**ADDENDUM NO. 3  
TO THE  
BIDDING REQUIREMENTS AND CONTRACT DOCUMENTS  
FOR THE  
CHANDLER 1.5 MILLION GALLON WATER TOWER PROJECT**

**ISSUED BY/ENGINEER:** Egis BLN USA, Inc.  
8320 Craig Street  
Indianapolis, Indiana 46250

**ISSUE DATE:** December 10<sup>th</sup>, 2025

PROJECT NO.

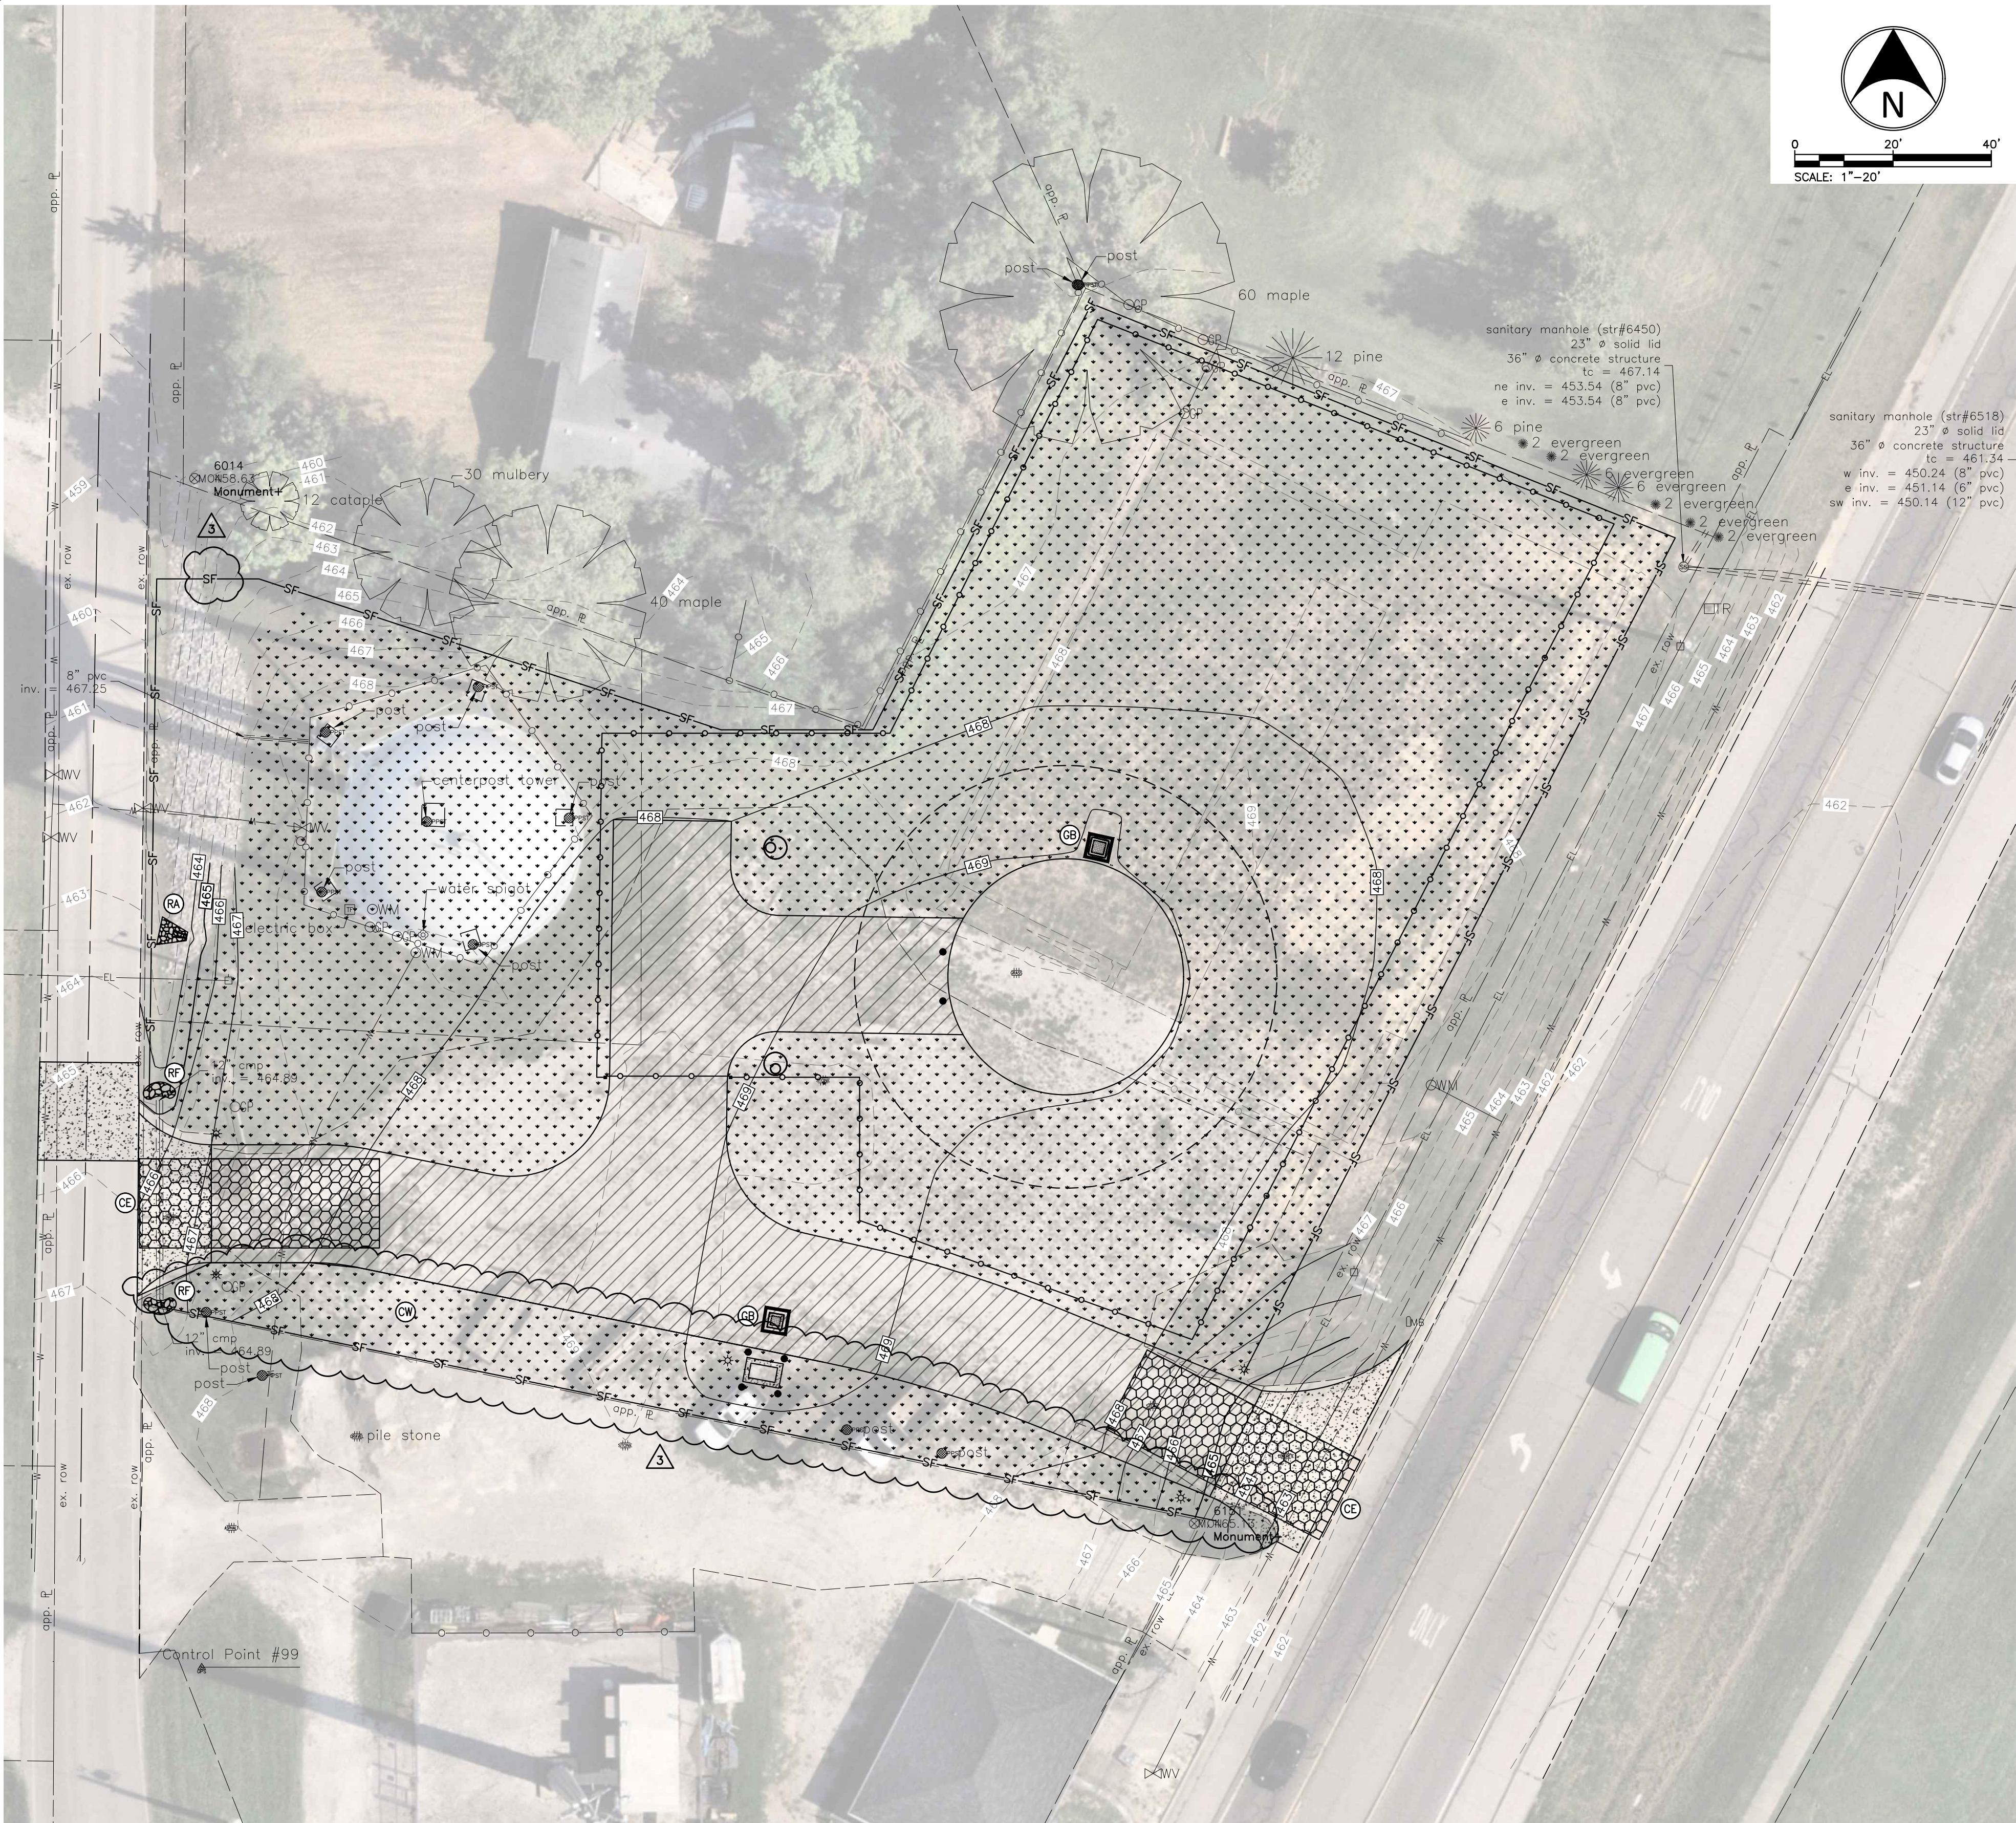
1. GIS property lines were added to the Frame Standpipe demolition plan to show approximate parcels.
2. Note was updated to indicate property lines taken from GIS.
